RE: Cecil R - Jackson Decision Record and Finding of No
Significant Impact - FONSI

RE: Cecil R - Jackson Decision Record and Finding of No Significant Impact - FONSI

The BLM received 32 letters in response to the Cecil R – Jackson Revised EA. Together these letters contained 55 separate comments that are responded to below.

Road Construction

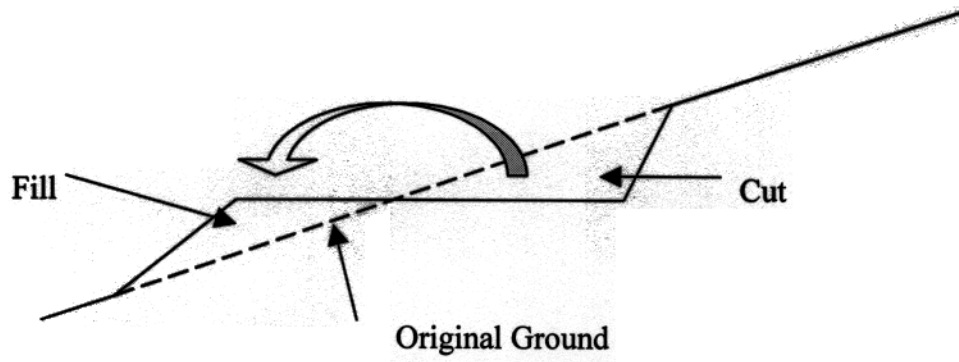
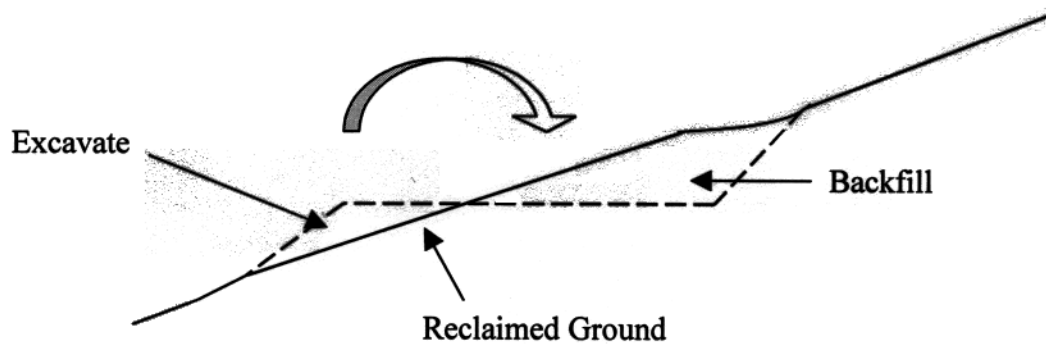
Comment 19: The EA should include a cross section showing road construction and reclamation.

Response 19: A figure is attached with these responses.
